# UNITED STATES PATENT AND TRADEMARK OFFICE

APPLICATION NO.	FILING DATE	FIRST NAMED INVENTOR	ATTORNEY DOCKET NO.	CONFIRMATION NO.
10/561,638	03/07/2007	Ernma Svenbrant	12400-057	2899

<b>Office Action Summary</b>	<b>Application No.</b>	<b>Applicant(s)</b>	
	10/561,638	SVENBRANT ET AL.	
	<b>Examiner</b>	<b>Art Unit</b>	
	James English	4155

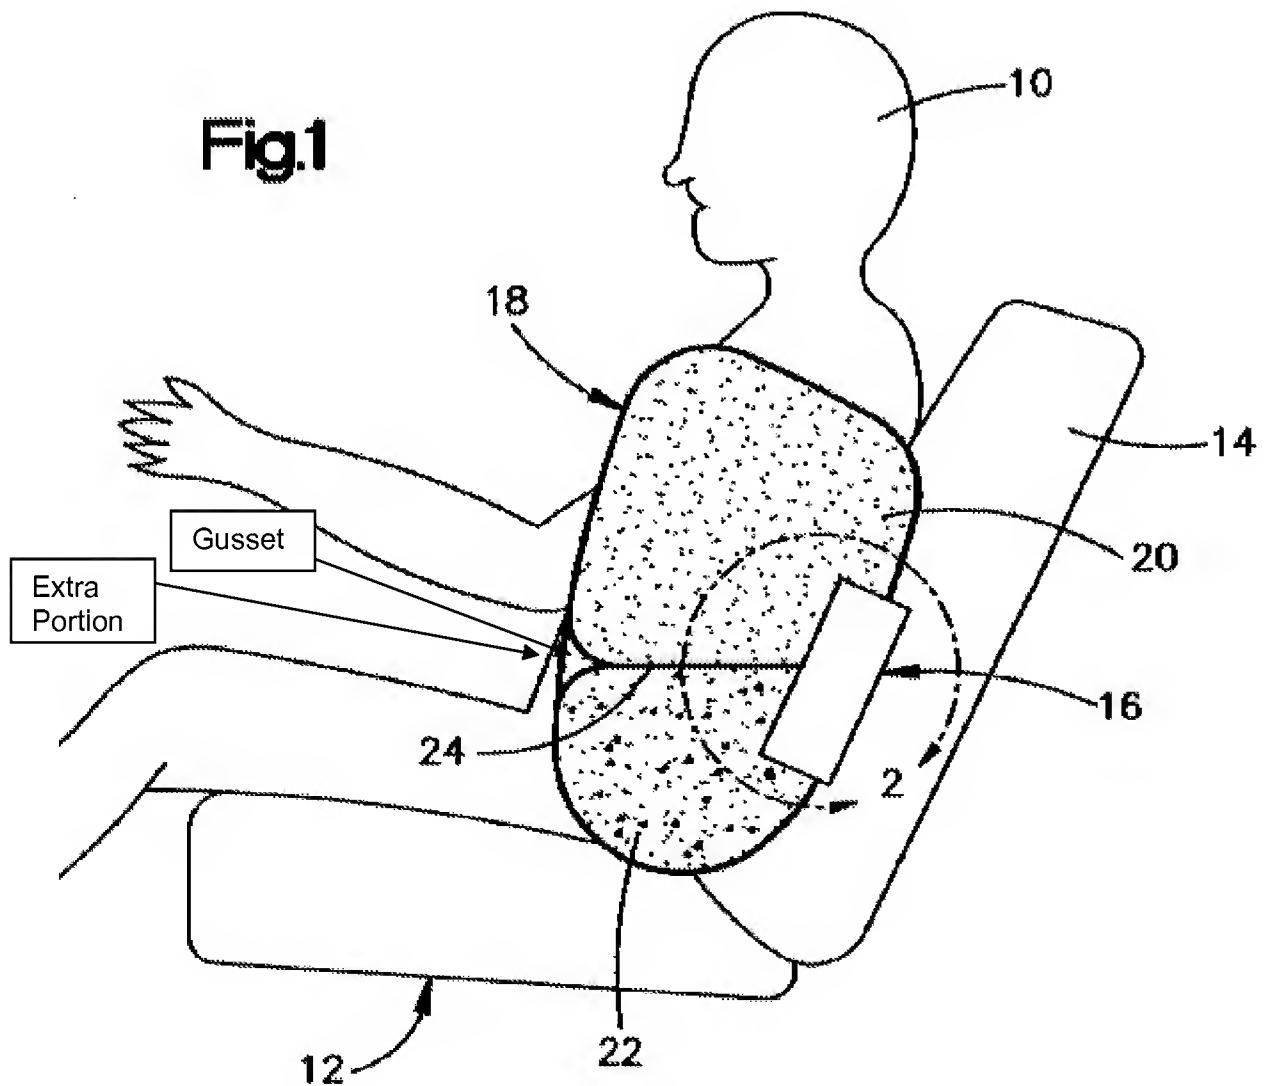
Consider claims 1-2 and 7-8, Acker et al. discloses a side air bag (18) having a compressed gas source (16) and a first chamber (20), inflated to the side of the thorax, and a second chamber (22), inflated to the side of the pelvis. (Fig. 1, column 3, lines 40-46.) The two chambers (20, 22) have a different internal pressure and are separated from each other by a dividing seam (24). (Fig. 1, column 3, lines 46-50.) This is analogous to two superimposed layers of fabric (driver facing side and window facing side of the side airbag) which, when laid flat, have a substantial common area of superimposition and include a gusset (Modified Fig. 1 - below) formed between the layers to create a three-dimensional shape; the airbag having an inflatable region towards the upper part of the airbag (20) and an inflatable region towards the lower part of the airbag (22), the inflatable regions being separated by a part of the airbag, when the airbag is inflated, constrained to have a thickness less than the thickness of the regions (Fig. 1). This is also analogous to the airbag having an upper chamber forming the upper region (20) and a lower chamber forming the lower region (22), the upper and lower chamber being separated by a transversely extending seam (24). This is also analogous to superimposed layers of fabric having a substantial common area of superimposition, and each layer of fabric has one or more extra portions thereof which project beyond the area of superimposition (Modified Fig. 1 - below), and the peripheries of the extra portions interconnected together by means of a seam (24) to form the gusset (Modified Fig. 1 - below). This is further analogous to a gas generator

(16) present in the airbag and the combination of the seam (24) and gas generator (16) substantially sealing the two chambers (20, 22) from each other, with the gas generator (16) configured to inflate the two chambers to different pressures.
